Re: Revised Conceptual Site Layout (dated June 5, 2024)

120 Turnpike Road 40B Apartment Bldg. Questions and Comments

Dated: June 12, 2024

From: Paul Carter - Town Resident 6 Hillside Avenue

Figure 2

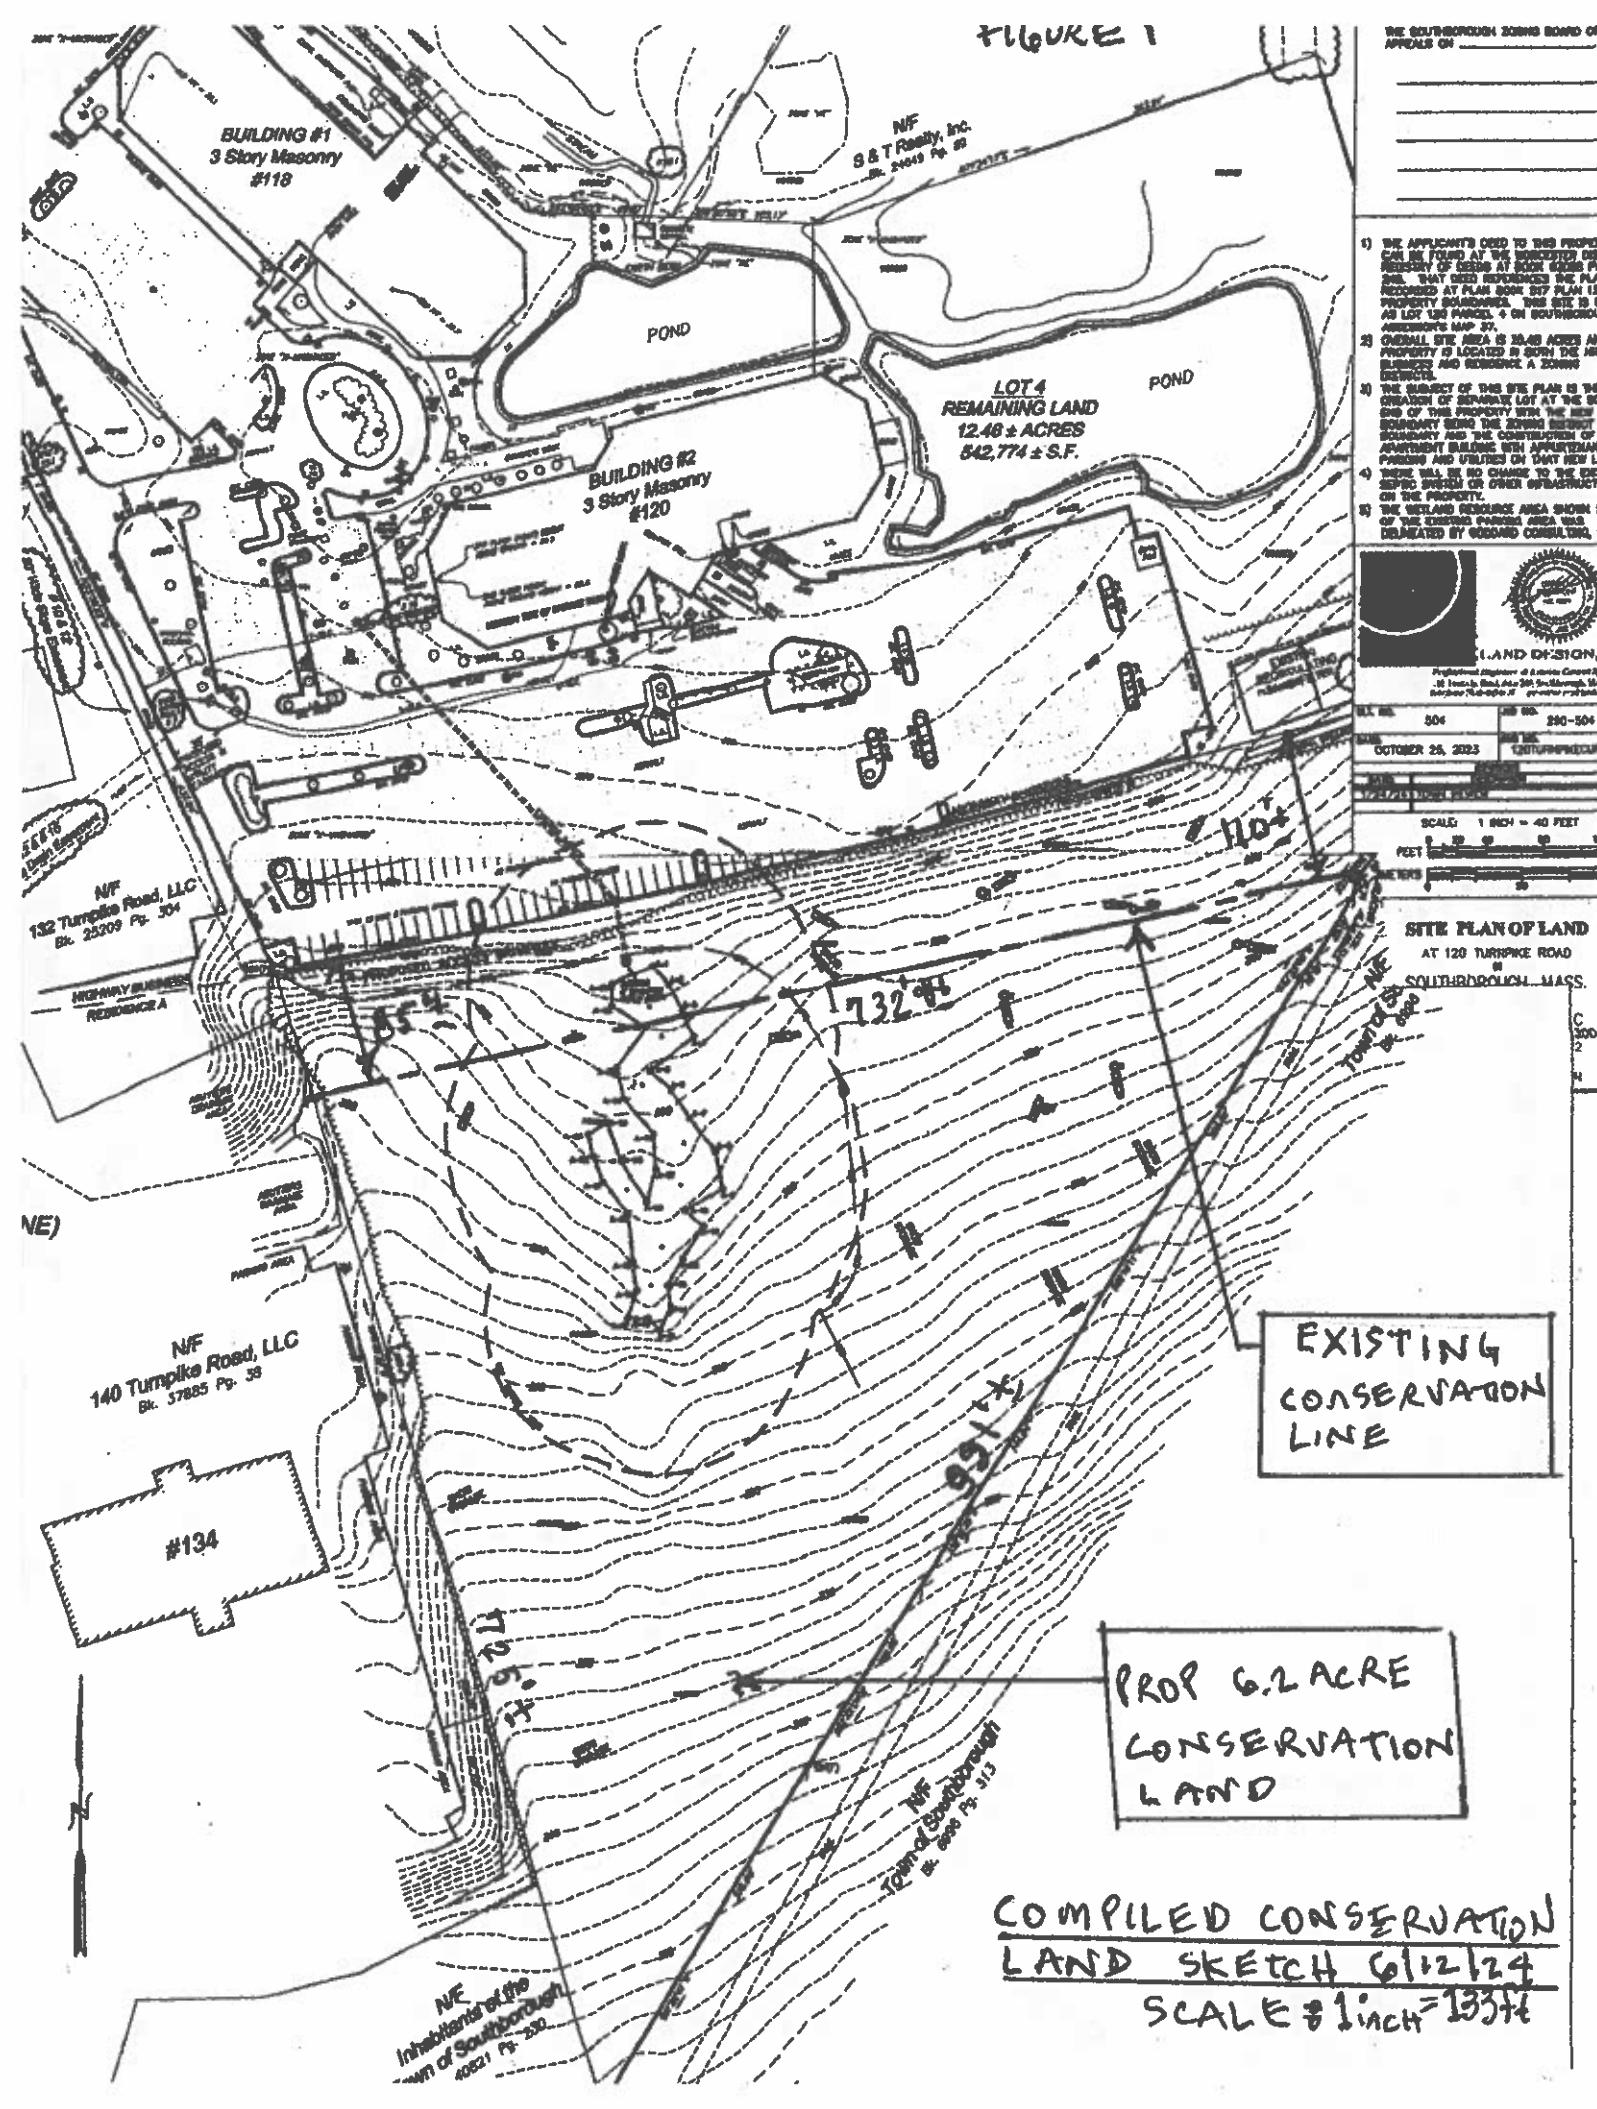
- a. The Revised Concept Site Layout Plan of Land shows the proposed Lot Lines and labels the proposed lots but it also needs to show the proposed lot areas and boundary dimensions as well as the limits of the proposed Preliminary Subdivision Road even it is only defined as a Roadway Easement over the proposed Lot 4A

- c. The Revised Concept Site Layout Plan shows the following within the 6.2-acre Conservation land:
 - i. a variable 5-24 foot width of the proposed access and parking aisle road

- ii. An Existing Relocated Recirculating Sand Filter that serves the existing office buildings
 - iii. The previously mentioned Proposed 40B Apartment septic disposal fields (labeled proposed Dog Park and playground)

4. The revised Comprehensive Permit Concept Layout Plan submission shows conflicting information regarding the disposition of the 6.2-acre Conservation Land (Proposed Lot 4C) and how it is divided between the Proposed Lot 4B (Proposed 60-unit 40B) and Conservation Land (Proposed Lot 4C)

FIGURE 3

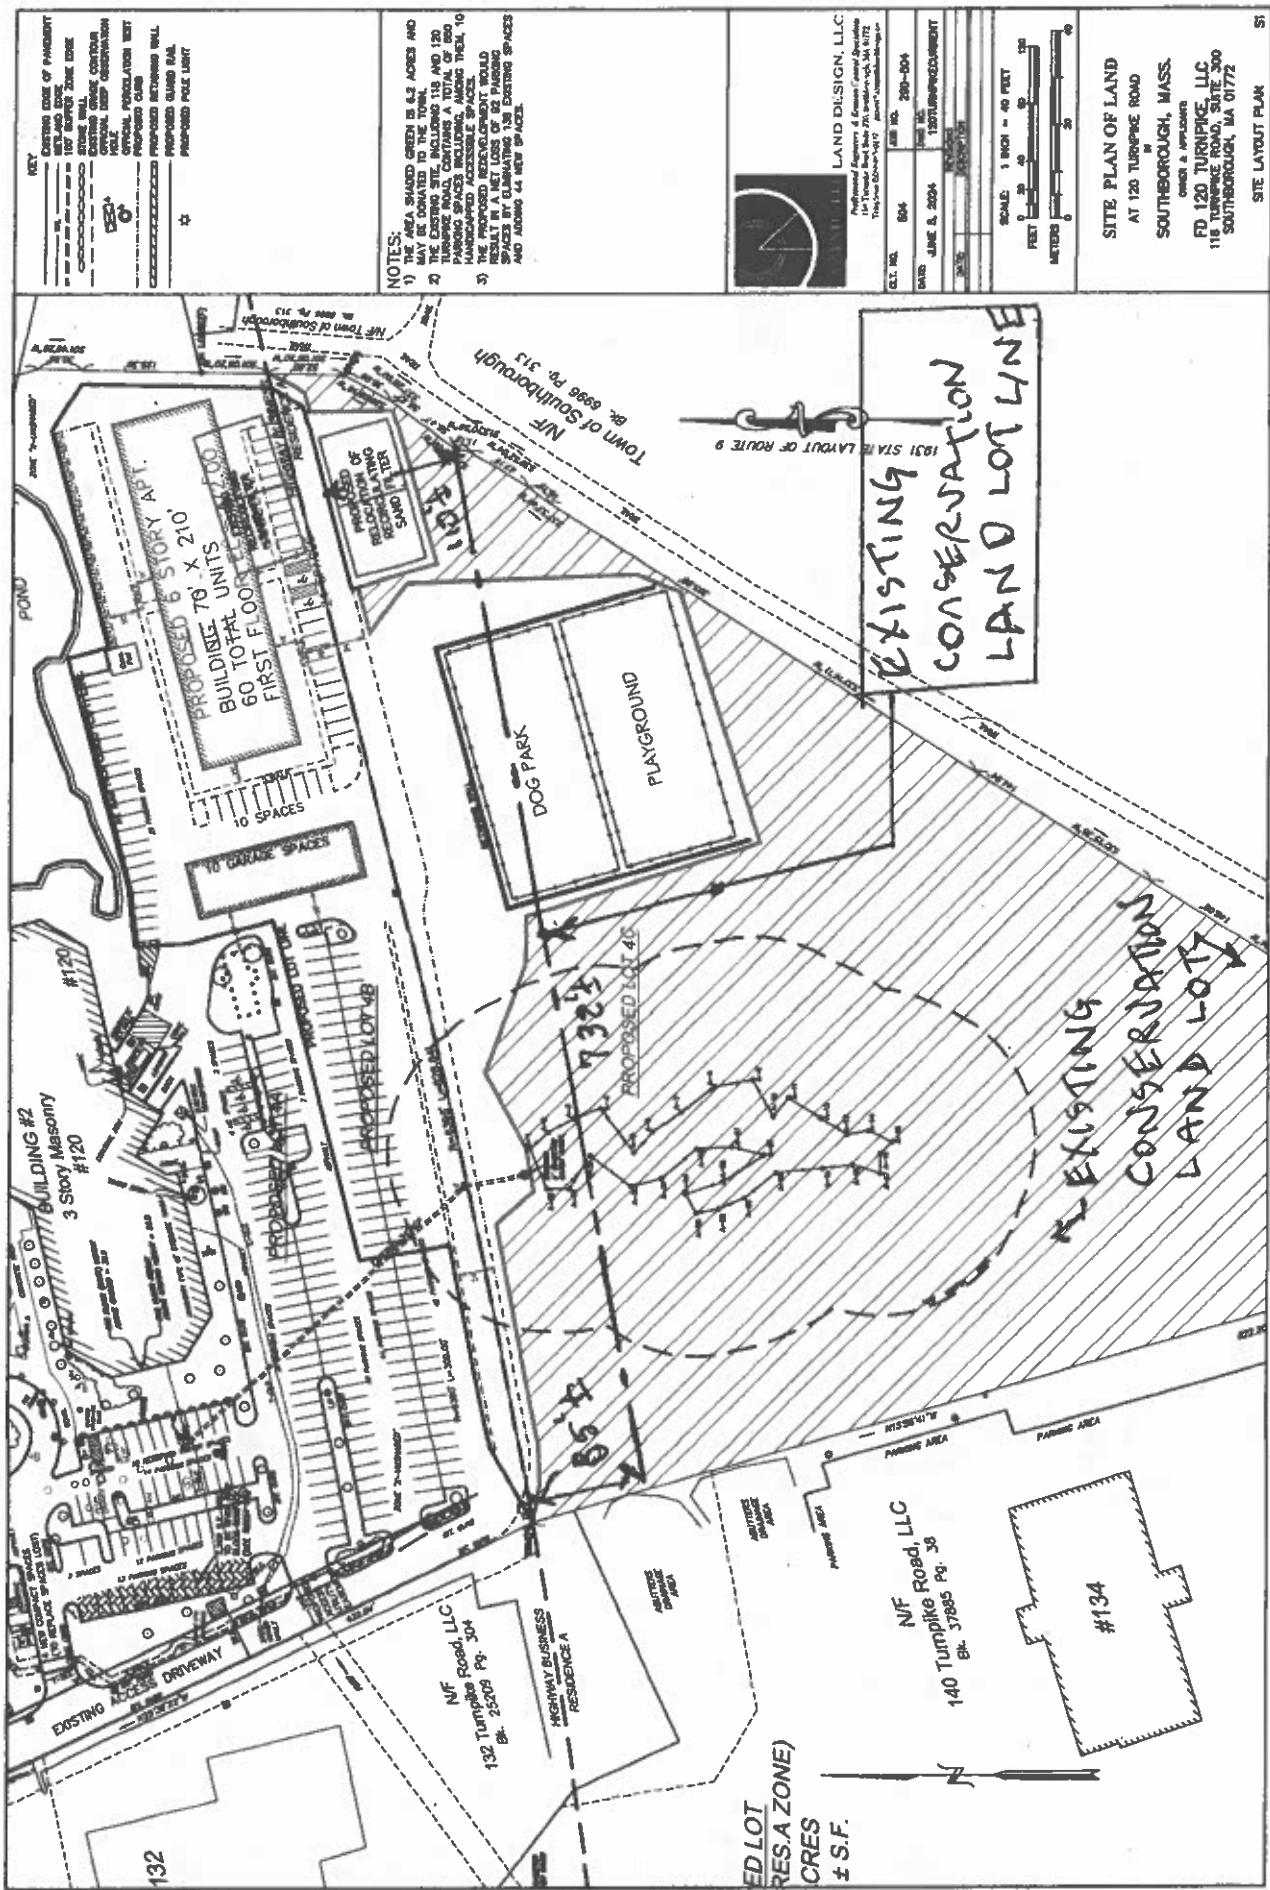
1. Proposed Six (6) Story Apartment Building significantly exceeds the Town of Southborough Building Height Maximum of Three (3) stories).
 - a. The Alternative Layout Concept dated 6/5/24 is an improvement over the Original Comprehensive Permit Plan because it moves the proposed apartment building away and off of the Breakneck Hill Conservation land. However, it increases the height of the apartment building from four (4) stories high to six (6) stories high.

- i. Just because the Southborough Fire Department apparently has a Ladder Truck that does not mean that the proposed six(6) story Apartment Building can be considered safe. The proposed Revised Concept plan shows the proposed 60 Unit Apartment building located at the end of a very long existing office park driveway that is likely longer than the maximum length of a cul-de-sac allowed by the existing Subdivision Regulations. The location of the proposed 60 Unit Apartment Building off of Eastbound Route 9 would be in danger if a fire
